PROJECT
# LAVILLE ELEMENTARY SCHOOL - 2020 IMPROVEMENTS AND RELATED WORK

| MARK | DATE | ISSUED FOR |
|---|---|---|
| AD-03 | 09/18/20 | ADDENDUM NO. 3 |

PROJECT
LAVILLE ELEMENTARY SCHOOL - 2020 IMPROVEMENTS

| MARK | DATE | ISSUED FOR |
|---|---|---|
| AD-3 | 09/18/20 | ADDENDUM NO. 3 |

## OVERALL ARCHITECTURAL ROOF PLAN

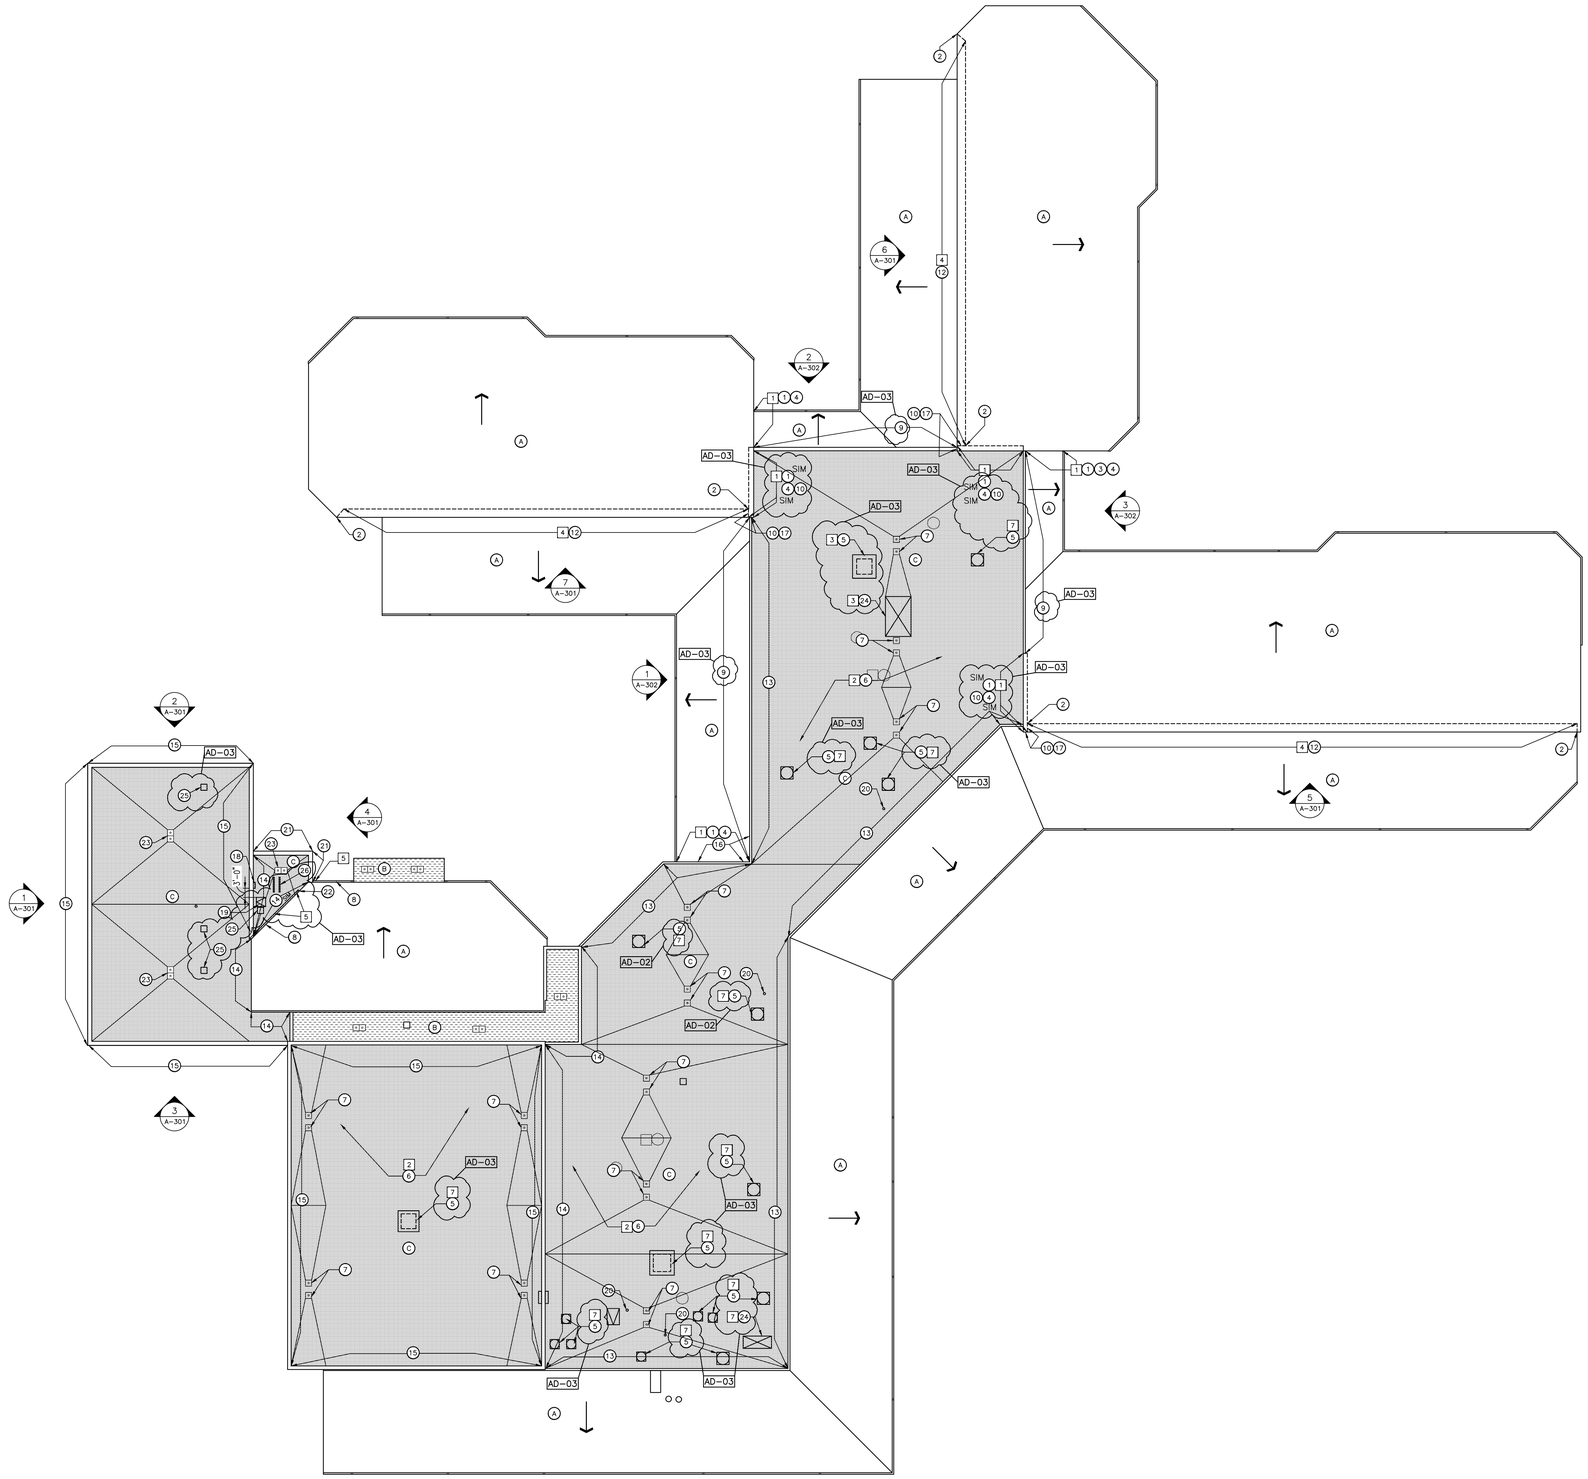
AD-03 C. NEW MEMBRANE ROOF SHEET W/ 4" TAPERED RIGID INSULATION AND 1/2" PROTECTION BOARD @ 1/4" SLOPE MINIMUM.

6. REMOVE EXISTING PARAPET DOWN TO BELOW ROOF DECK.
7. AD-03 EXISTING MECHANICAL EQUIPMENT TO BE REMOVED FOR REINSTALLATION. MOVE EQUIPMENT AS REQUIRED TO RECEIVE NEW CURB FLASHING AND COUNTER-FLASHING.

7. AD-03 ROOF DRAIN W/ OVERFLOW AND PIPING TO REMAIN. ADJUST ASSEMBLY TO ACCOMMODATE NEW ROOF. — 1/A-211
8. MODIFY EXISTING GUTTER TO ACCOMMODATE NEW CONSTRUCTION. — 2/A-301

11. PROVIDE NEW FLASHING MEMBRANE TO OVERLAP AND TIE INTO EXISTING ROOF MEMBRANE AS REQUIRED TO MAINTAIN EXISTING ROOF WARRANTY.
12. NEW TRANSLUCENT WALL PANEL SYSTEM. INSTALL NEW FLASHING AND COUNTER-FLASHING CONTINUOUS ALONG PERIMETER OF OPENING. — 3/A-212, 4/A-212, AD-03
    ALTERNATE BID: NEW STOREFRONT.

22. NEW DOWNSPOUT AND SPLASH BLOCK - CONNECT TO EXISTING GUTTER.
23. ROOF DRAIN WITH OVERFLOW. — 13/A-211
24. AD-03 EXISTING LARGE EQUIPMENT AND ROOF CURB TO REMAIN. TUCK AND INSTALL NEW FLASHING AND COUNTER-FLASHING. WRAP MEMBRANE AND INSTALL NEW TERMINATION BAR AS REQUIRED FOR WATERTIGHT CONDITIONS. ENSURE 8" IS MAINTAINED FROM TERMINATION BAR TO ROOF OR AS REQUIRED FOR WATERTIGHT CONDITIONS AND WARRANTY REQUIREMENT.

OVERALL FLOOR PLANS - MECHANICAL HVAC

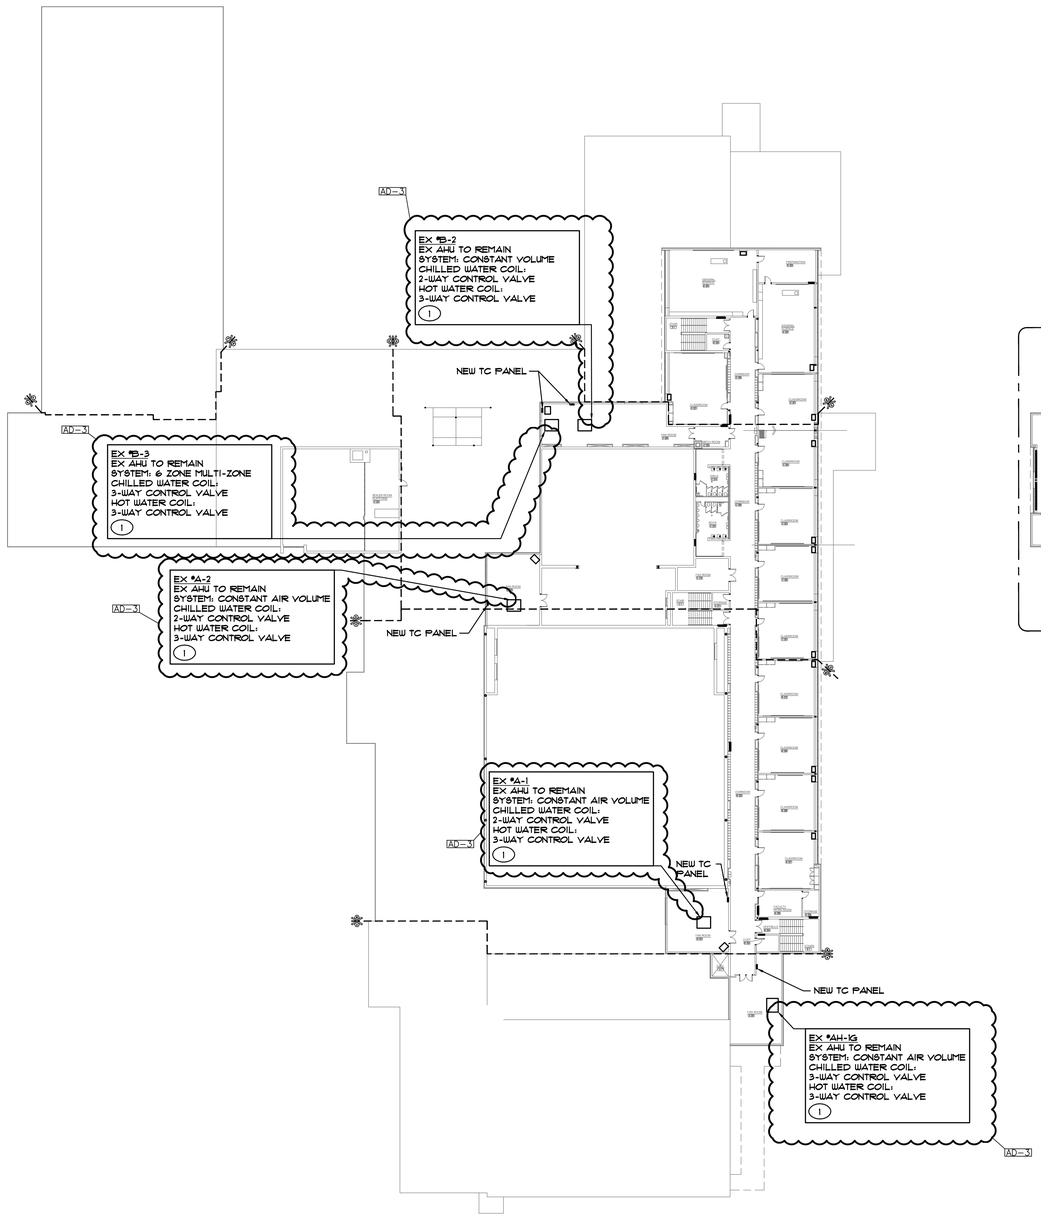
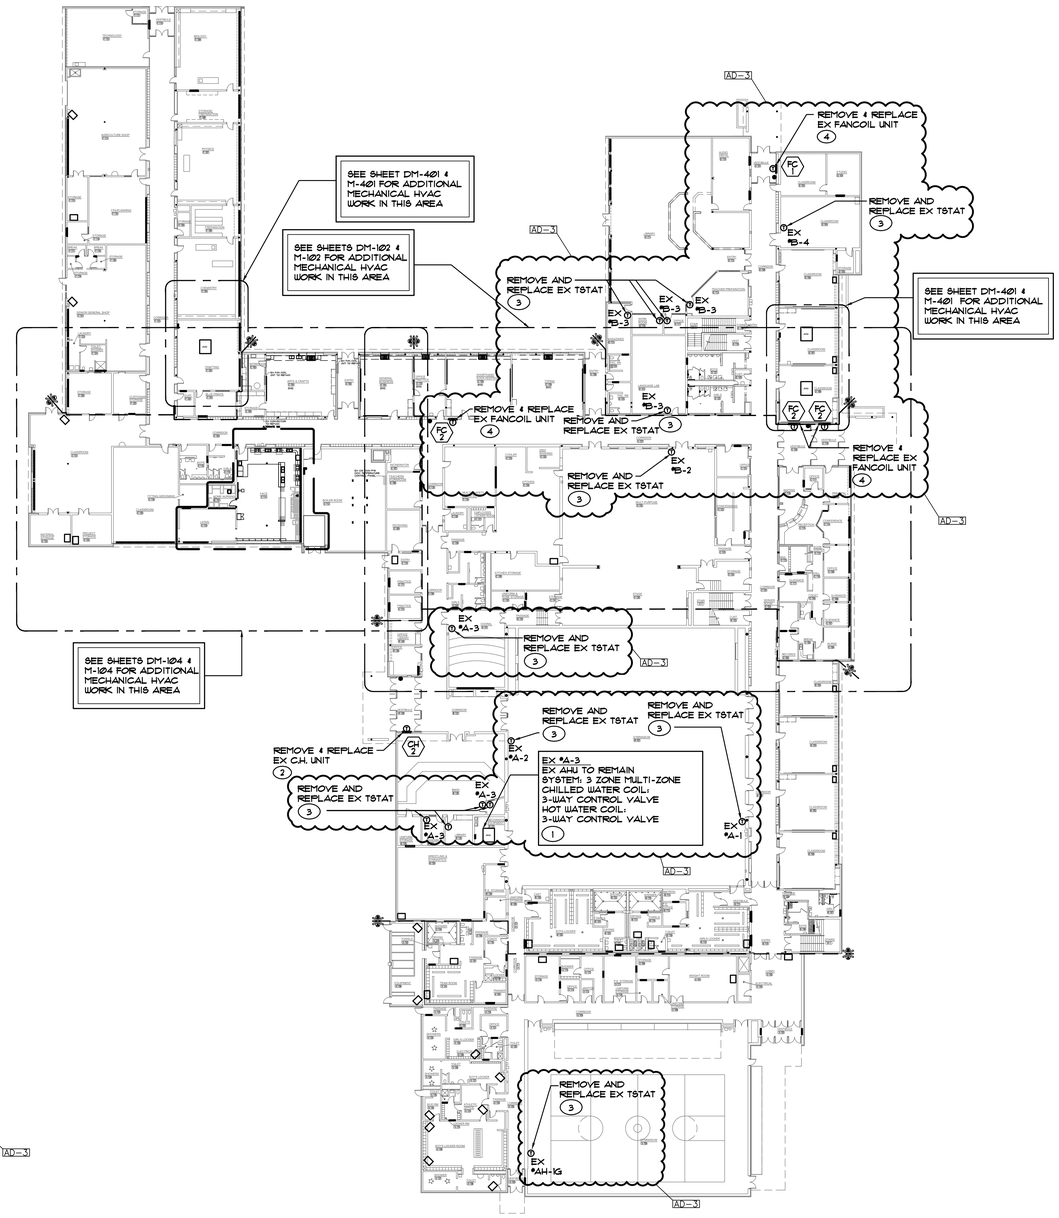
1. PROVIDE A DIRECT DIGITAL CONTROLLER FOR THE AIR HANDLING UNIT TO BE INTERFACED INTO THE EXISTING ICS DDC TEMPERATURE CONTROL SYSTEM. EXISTING AIR HANDLING UNITS HAVE HOT WATER HEATING COIL, CHILLED WATER COOLING COIL, 2 AND 3 WAY COIL CONTROL VALVES, SMOKE DETECTION, AND ELECTRIC DAMPER AND CONTROL VALVE ACTUATORS. PROVIDE ALL NECESSARY SENSORS, COMPONENTS, WIRING, DEVICES, ETC. TO FULLY INTEGRATE AND CONTROL THE AIR HANDLING UNIT, ELECTRIC DAMPER ACTUATORS, ELECTRIC CONTROL VALVES, ROOM SENSORS/THERMOSTATS, ETC. TO THE ICS FMS SYSTEM. PROVIDE ADDITIONAL ICS FMS CONTROLLER/SERVERS, PROGRAMMING AND GRAPHICS FOR EXISTING CONSTANT VOLUME AND MULTI-ZONE AIR HANDLING UNITS, DAMPERS AND COIL CONTROL VALVES, ZONE SENSORS, ETC. FOR A COMPLETE AND 100% INTEGRATED OPERATIONAL SYSTEM. ALL EXISTING SEQUENCES, CONTROL POINTS, MONITOR POINTS, MONITOR POINTS, ETC SHALL REMAIN THE SAME. VERIFY EXACT REQUIREMENTS IN THE FIELD. SEE MECHANICAL SPECIFICATIONS FOR TEMPERATURE CONTROL SEQUENCES.

2. REMOVE EXISTING WALL MOUNTED CABINET HEATER. DISCONNECT EXISTING ASSOCIATED PIPING, PNEUMATIC TEMPERATURE CONTROL VALVE ON HEATING & COOLING PIPING, CONTROLS, ELECTRICAL CONNECTIONS, ETC COMPLETE AS REQUIRED. INSTALL NEW CABINET HEATER IN LOCATION AND MODIFY AND RECONNECT ALL ASSOCIATED PIPING, CONTROLS, ELECTRICAL CONNECTIONS, ETC. COMPLETE AS REQUIRED. PROVIDE NEW 2-WAY ELECTRIC DDC TEMPERATURE CONTROL VALVES ON HEATING PIPING COMPLETE AS REQUIRED.

3. REMOVE EXISTING THERMOSTAT AND ASSOCIATED TUBING/WIRING, ETC. COMPLETE AS REQUIRED. INSTALL NEW DDC THERMOSTAT AND CONTROL WIRING TO PROPER EXISTING AIR HANDLING UNIT

4. REMOVE EXISTING WALL MOUNTED FAN COIL UNIT. DISCONNECT EXISTING ASSOCIATED HOT WATER, CHILLED WATER, CONDENSATE PIPING, PNEUMATIC TEMPERATURE CONTROL VALVE ON HEATING & COOLING PIPING, CONTROLS, ELECTRICAL CONNECTIONS, ETC. COMPLETE AS REQUIRED. INSTALL NEW FAN COIL UNIT IN LOCATION AND MODIFY AND RECONNECT ALL ASSOCIATED HOT WATER, CHILLED WATER, CONDENSATE PIPING, CONTROLS, ELECTRICAL CONNECTIONS, ETC. COMPLETE AS REQUIRED. PROVIDE NEW 2-WAY ELECTRIC DDC TEMPERATURE CONTROL VALVES ON HEATING & COOLING PIPING COMPLETE AS REQUIRED. INSTALL NEW DDC THERMOSTAT ON WALL IN OLD THERMOSTAT LOCATION AS REQUIRED.

AD-3

AD-2 UNIT "F & C" BASEMENT/TUNNEL MECHANICAL PLAN

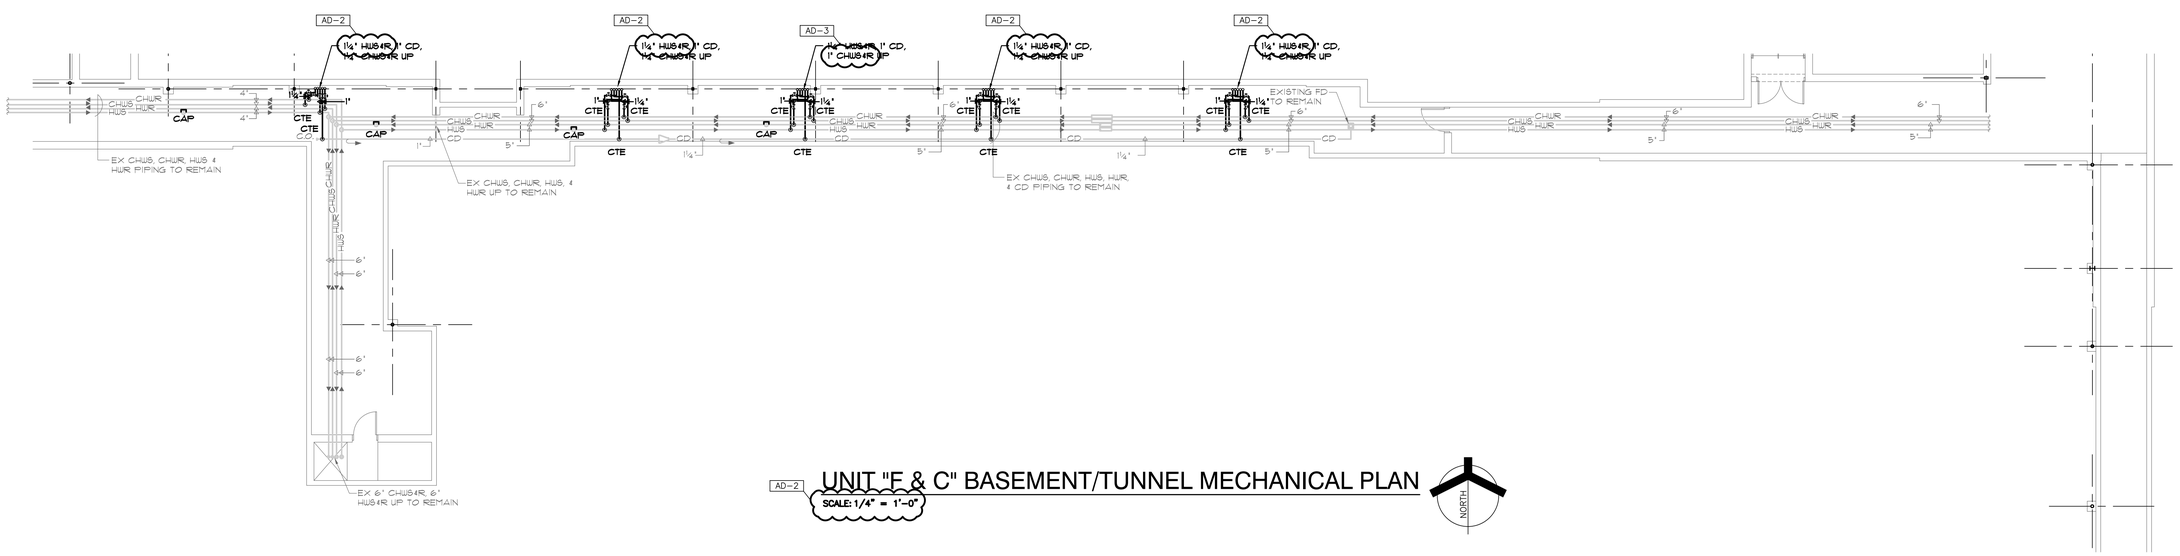
1. PROVIDE A DIRECT DIGITAL CONTROLLER FOR THE AIR HANDLING UNIT TO BE INTERFACED INTO THE EXISTING ICS DDC TEMPERATURE CONTROL SYSTEM. EXISTING AIR HANDLING UNITS HAVE HOT WATER HEATING COIL, CHILLED WATER COOLING COIL, 2 OR 3 WAY COIL CONTROL VALVES, SMOKE DETECTION, AND ELECTRIC DAMPER AND CONTROL VALVE ACTUATORS. PROVIDE ALL NECESSARY SENSORS, COMPONENTS, WIRING, DEVICES, ETC. TO FULLY INTEGRATE AND CONTROL THE AIR HANDLING UNIT, ELECTRIC DAMPER ACTUATORS, ELECTRIC CONTROL VALVES, ROOM SENSORS/THERMOSTATS, ETC. TO THE ICS FMS SYSTEM. PROVIDE ADDITIONAL ICS FMS CONTROLLER/SERVERS, PROGRAMMING AND GRAPHICS FOR EXISTING CONSTANT VOLUME AND MULTI-ZONE AIR HANDLING UNITS, DAMPERS AND COIL CONTROL VALVES, ZONE SENSORS, ETC. FOR A COMPLETE AND 100% INTEGRATED OPERATIONAL SYSTEM. ALL EXISTING SEQUENCES, CONTROL POINTS, MONITOR POINTS, MONITOR POINTS, ETC SHALL REMAIN THE SAME. VERIFY EXACT REQUIREMENTS IN THE FIELD. SEE MECHANICAL SPECIFICATIONS FOR TEMPERATURE CONTROL SEQUENCES.

2. REMOVE EXISTING THERMOSTAT AND ASSOCIATED TUBING/WIRING, ETC COMPLETE AS REQUIRED. INSTALL NEW DDC THERMOSTAT AND CONTROL WIRING TO PROPER EXISTING AIR HANDLING UNIT.
